H11319

## DESCRIPTIVE REPORT

### **HYDROGRAPHIC SURVEY H11319**

**ATLANTIC HYDROGRAPHIC BRANCH  
EVALUATION REPORT FOR H11319 (2004)**

*Figure 1.1.1*

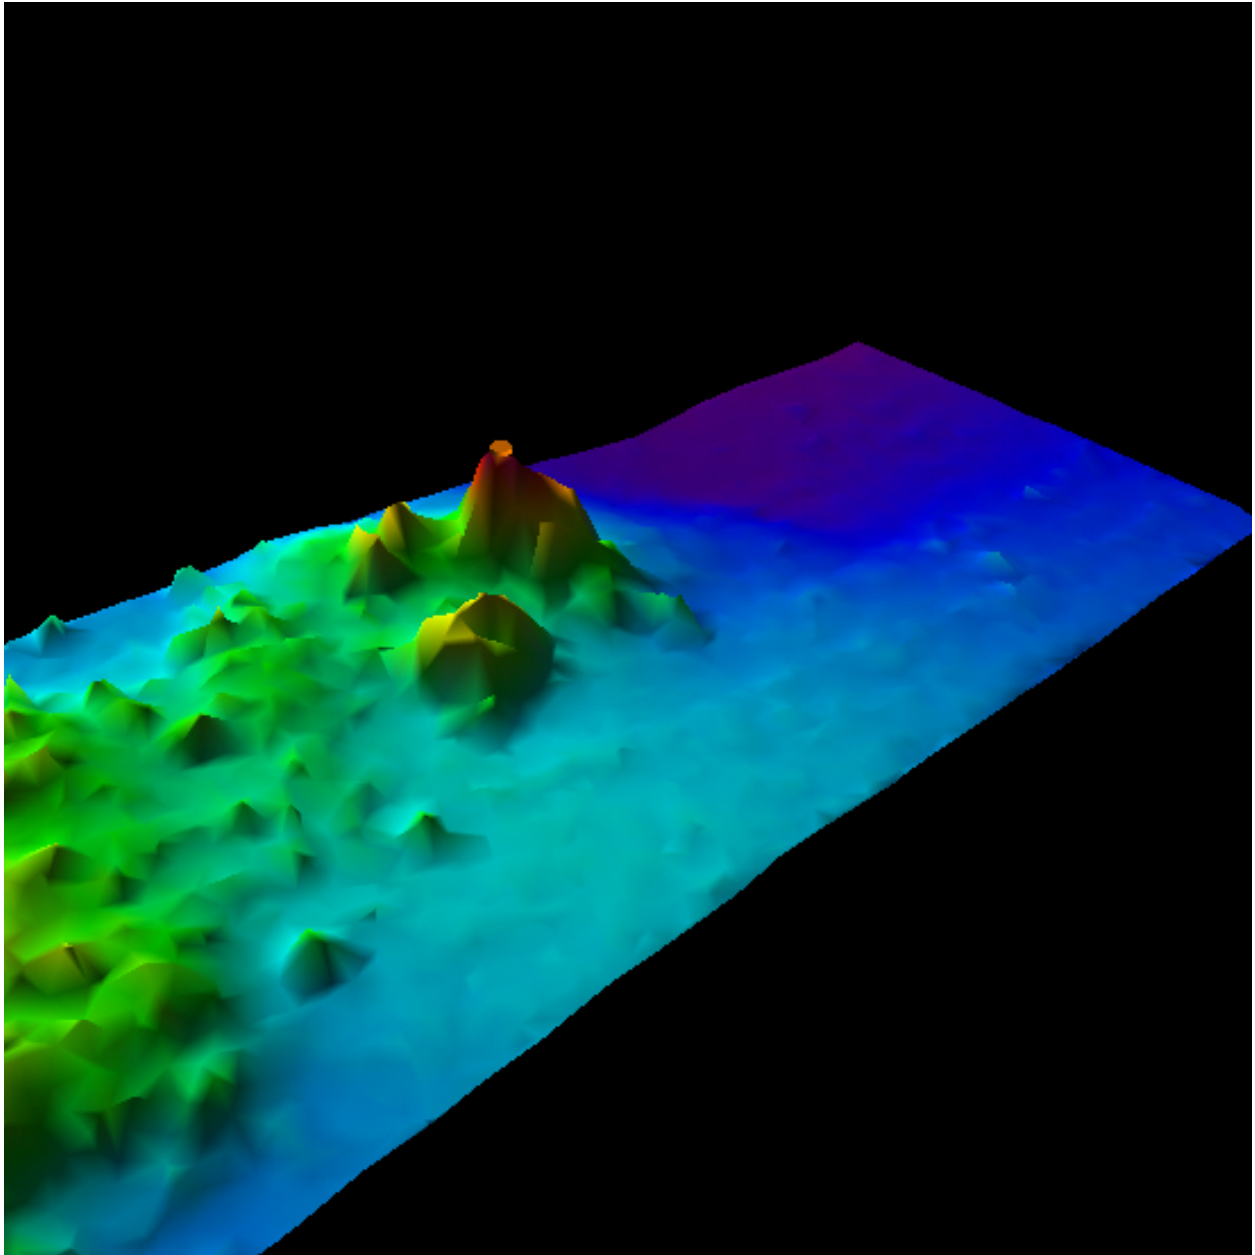
remove charted 41ft rk and chart as 40ft rk

Concur, remove Charted 41' dangerous rock and chart a 40' dangerous rock in present survey location.

*Figure 1.2.1*

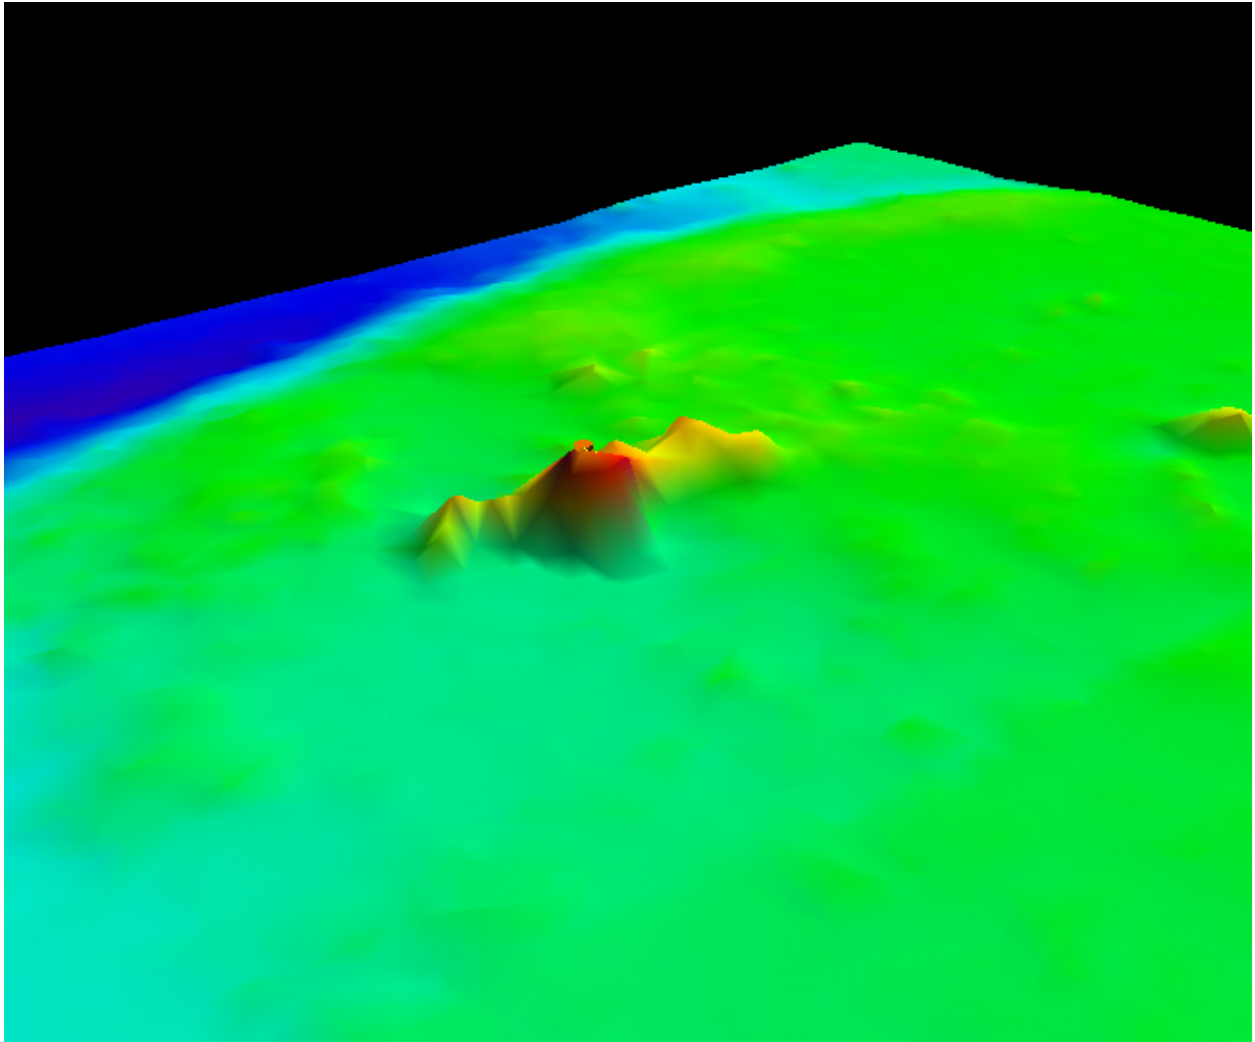
Remove charted 33ft rk and chart as 34ft rk

Concur, remove charted 33' dangerous rock and chart a 34' dangerous rock in present survey location.

*Figure 2.1.1*

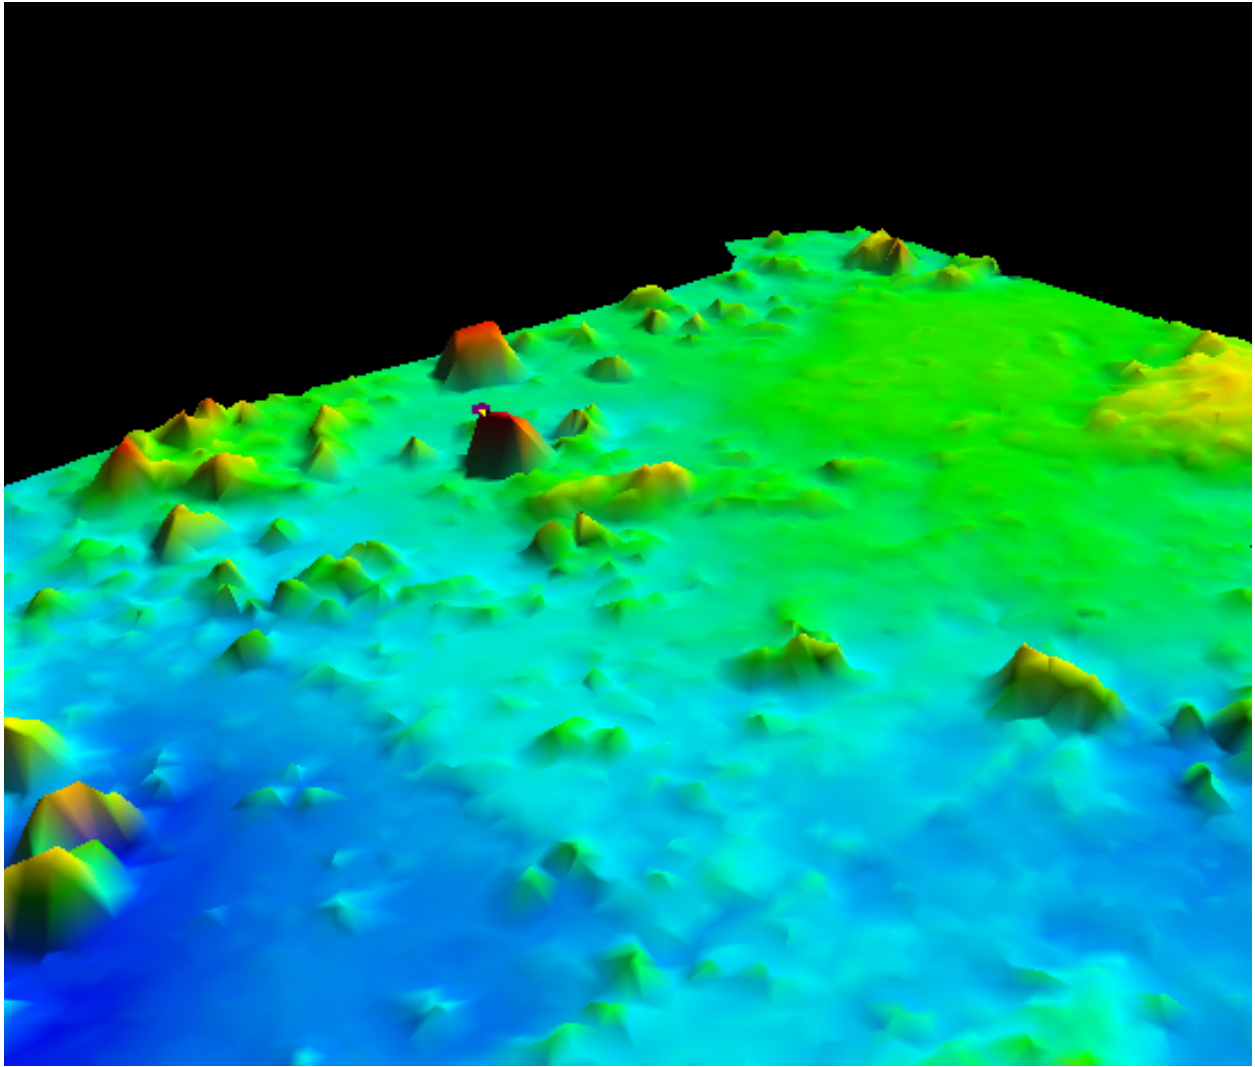
Remove adj 30ft snd. Chart as 39ft Rk

Concur with clarification. Add a 39 foot dangerous rock in the present survey location where charting scale permits.

*Figure 2.2.1*

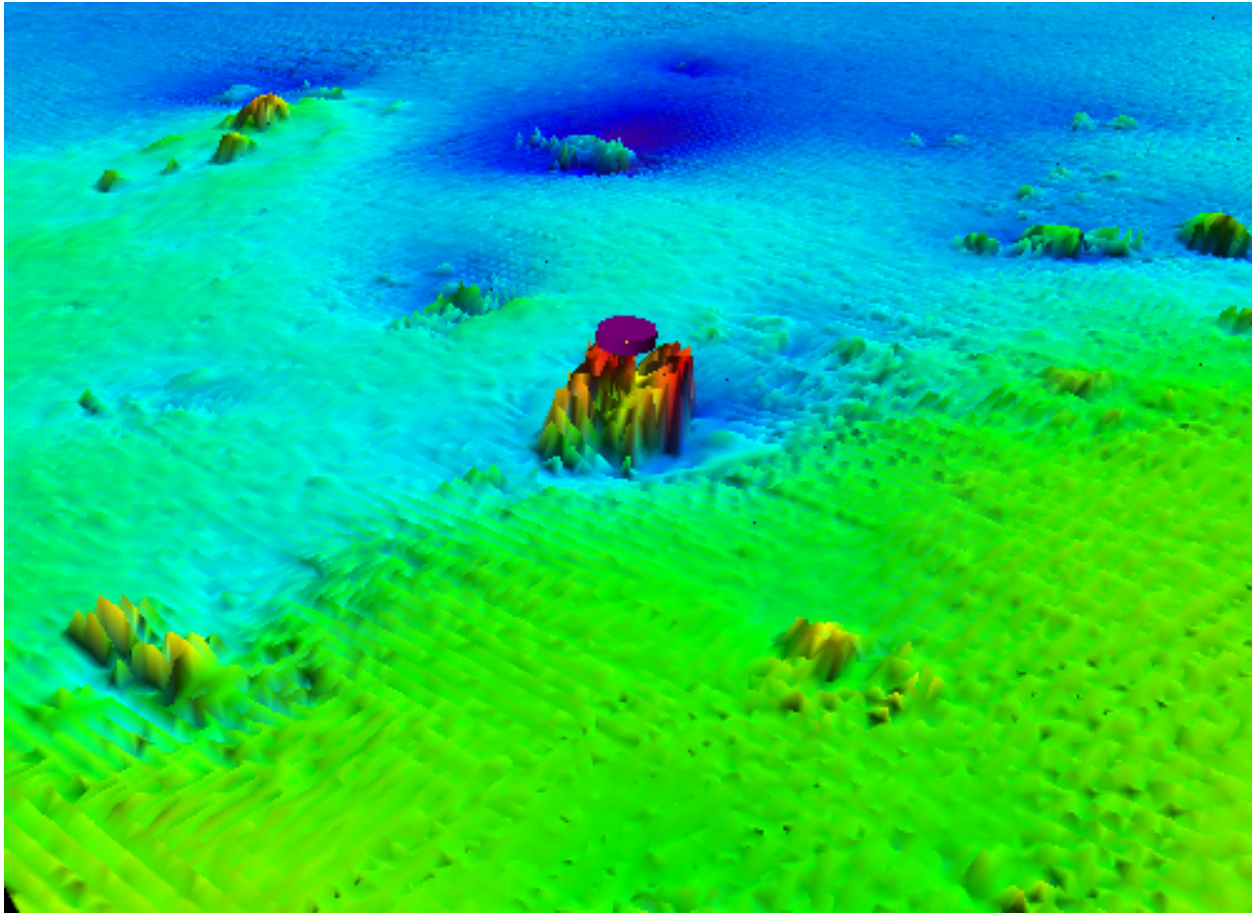
chart as 41ft rk

Concur. Chart a dangerous 41 ft rock.

*Figure 2.3.1*

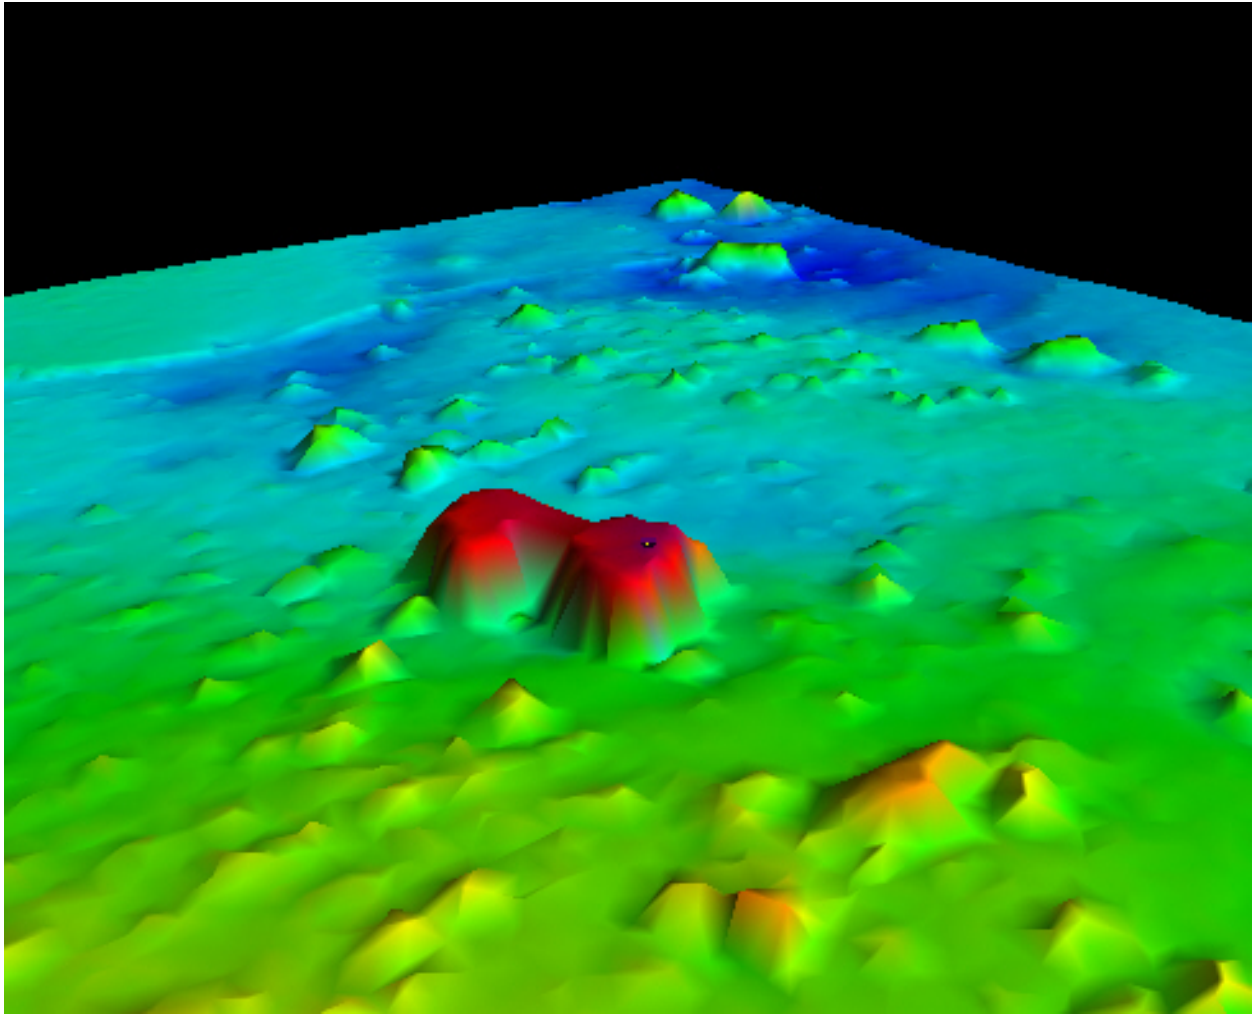
Chart as 40ft rk

Concur. Chart a 40ft dangerous Rk
